No. 88-14

REVISED  
6-21-89

## Correct Seawater Pump Kit for Closed Cooling Kit P/N 91036A1, -A3, -A5

Figure 1.

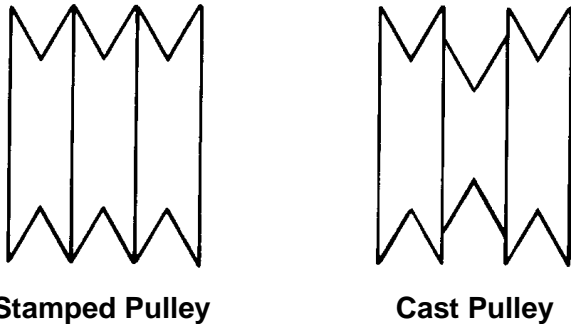
Before ordering closed cooling kit P/N 91036A1, 91036A3, 91036A5, and related seawater pump kits P/N 47-72774A37 and P/N 47-72774A56 you first must check what type of engine crankshaft pulley is installed. Engines equipped with stamped crankshaft pulley (Figure 1), use seawater pump kit P/N 46-72774A37. Engines equipped with a cast crankshaft pulley (Figure 1), use seawater pump kit P/N 47-72774A56.

Figure 2.

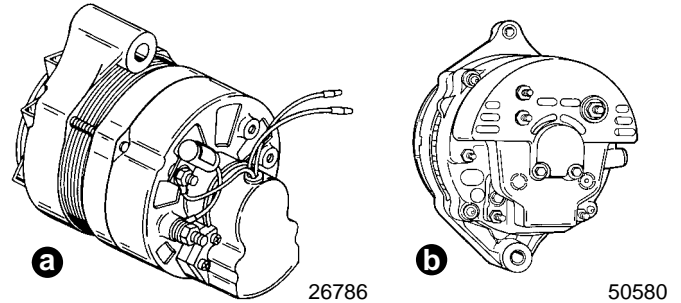
New 4.3L fluid mounts cannot be retrofitted onto an engine that originally had non fluid mounts without changing the following parts:

Fluid Mount	18098A3
Mount Bracket	18645T
Engine Coupler	18643A2
Manifold Hose Fitting 45° (Starboard)	22-92499
Hose (Starboard)	32-18810
Alternator (Figure 2)	92497A3

- a - Mando or Motorola with external voltage regulator must have the rear half rotated 180° to clear the fluid mount.
- b - Prestolite with internal voltage regulator can be used as is.
